Florida Power & Light Company, 6501 S. Ocean Drive, Jensen Beach, FL 34957

L-2008-121  
10 CFR 50.90

RE: St. Lucie Units 1 and 2  
Docket Nos. 50-335 and 50-389  
Proposed License Amendment  
Request for Additional Information Response  
Alternative Source Term Amendment – TAC Nos. MD6173 and MD6202

**3/4.3.3 MONITORING INSTRUMENTATION**

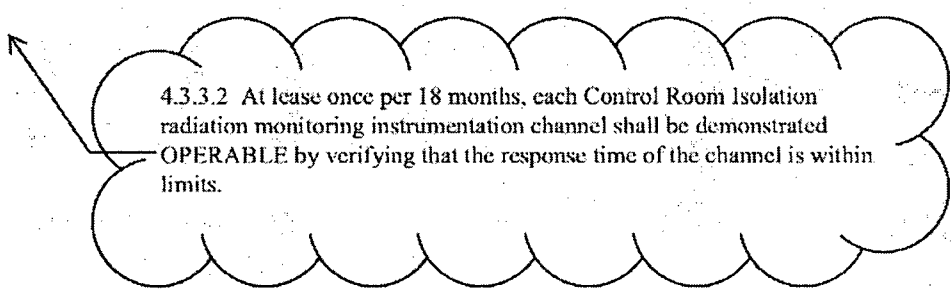
4.3.3.2 At least once per 18 months, each Control Room Isolation radiation monitoring instrumentation channel shall be demonstrated OPERABLE by verifying that the response time of the channel is within limits.

**3/4.3.3 MONITORING INSTRUMENTATION**

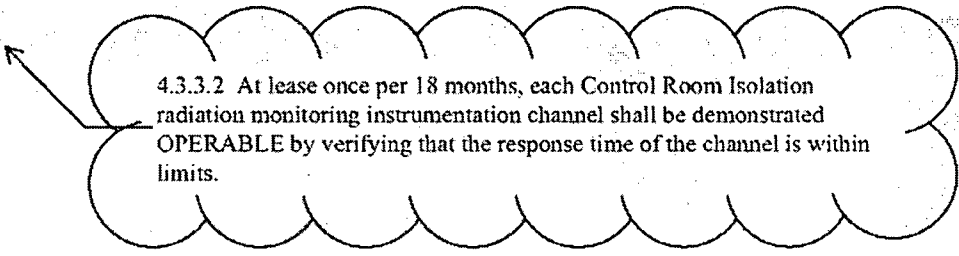
4.3.3.2 At lease once per 18 months, each Control Room Isolation radiation monitoring instrumentation channel shall be demonstrated OPERABLE by verifying that the response time of the channel is within limits.

≤ 320 cpm
